APPROVED MINUTES

December 20, 2012 Standards Committee Meeting

RE: Minutes from the December 20, 2012 Standards Committee Meeting

REVISION TO SPECIAL PROVISIONS AND STANDARD DRAWINGS
 PROPOSED NEW 805-SDAC-02 SIGNAL DUAL ARM CANTILEVERS

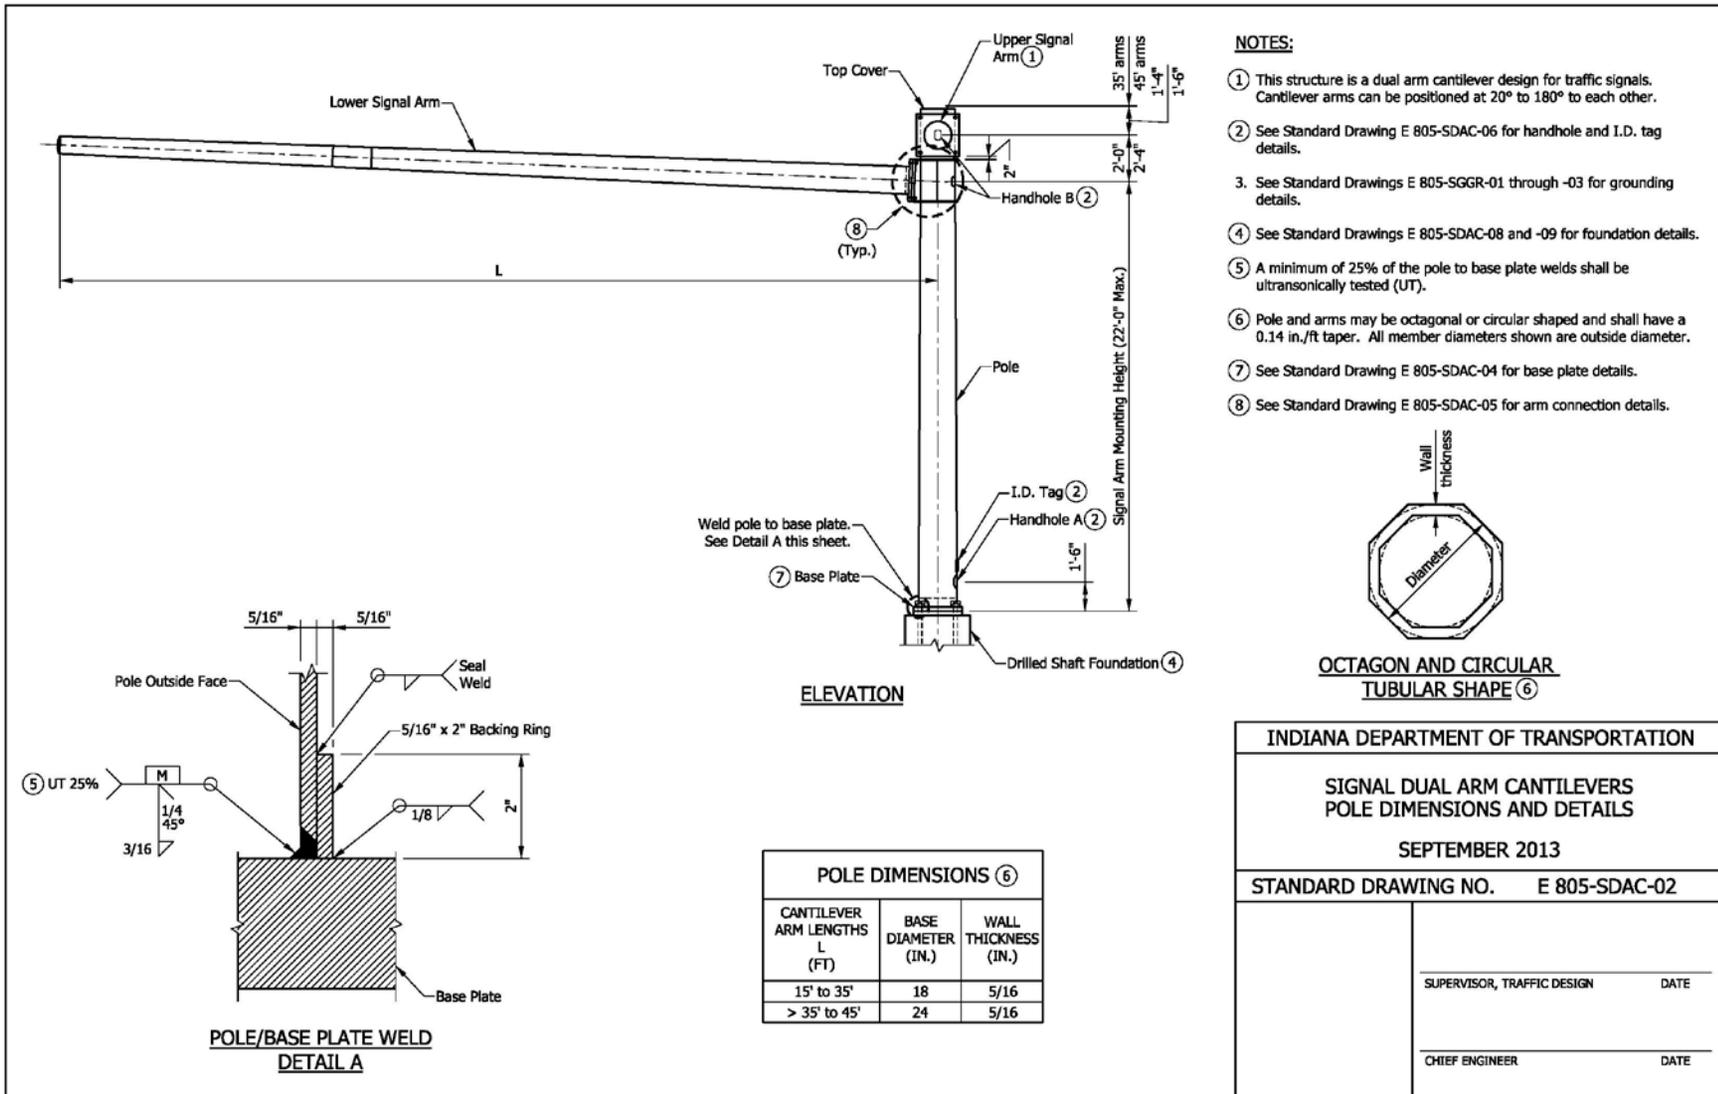
805-SGLT-01	LOOP TAGGING SYSTEM
805-SDAC-01	SIGNAL DUAL ARM CANTILEVERS DRAWING INDEX
805-SDAC-02	SIGNAL DUAL ARM CANTILEVERS POLE DIMENSIONS AND DETAILS
805-SDAC-03	SIGNAL DUAL ARM CANTILEVERS ARM DIMENSIONS AND DETAILS
805-SDAC-04	SIGNAL DUAL ARM CANTILEVERS BASE PLATE AND POLE TOP COVER DETAILS
805-SDAC-05	SIGNAL DUAL ARM CANTILEVERS ARM CONNECTION DETAILS
805-SDAC-06	SIGNAL DUAL ARM CANTILEVERS HANDHOLE AND I.D. TAG DETAILS
805-SDAC-07	SIGNAL DUAL ARM CANTILEVERS LOADING DIAGRAMS
805-SDAC-08	SIGNAL DUAL ARM CANTILEVERS FOUNDATION, DRILLED SHAFT TYPE E FOR DUAL ARMS 35' OR LESS
805-SDAC-09	SIGNAL DUAL ARM CANTILEVERS FOUNDATION, DRILLED SHAFT TYPE F FOR DUAL ARMS GREATER THAN 35' TO 45'

INDIANA DEPARTMENT OF TRANSPORTATION	
SIGNAL DUAL ARM CANTILEVERS LOADING DIAGRAMS	
SEPTEMBER 2013	
STANDARD DRAWING NO. E 805-SDAC-07	
	SUPERVISOR, TRAFFIC DESIGN DATE
	CHIEF ENGINEER DATE

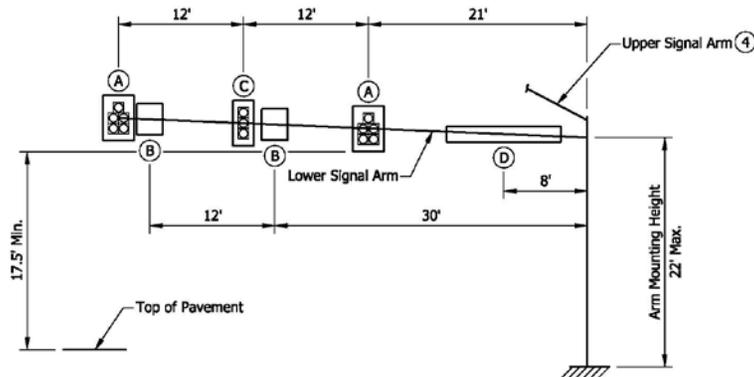
1. The arms and pole are designed for the loading conditions shown. For arm lengths shorter than 35', the loading shall not exceed the loading shown for the 35' arm length.
2. Foundation Type E is designed for arm length of 35' or less. See Standard Drawing E 805-SDAC-08.
3. Foundation Type F is designed for arm length of greater than 35' to 45'. See Standard Drawing E 805-SDAC-09.
- ④ Both arms can be loaded as shown in loading diagrams.
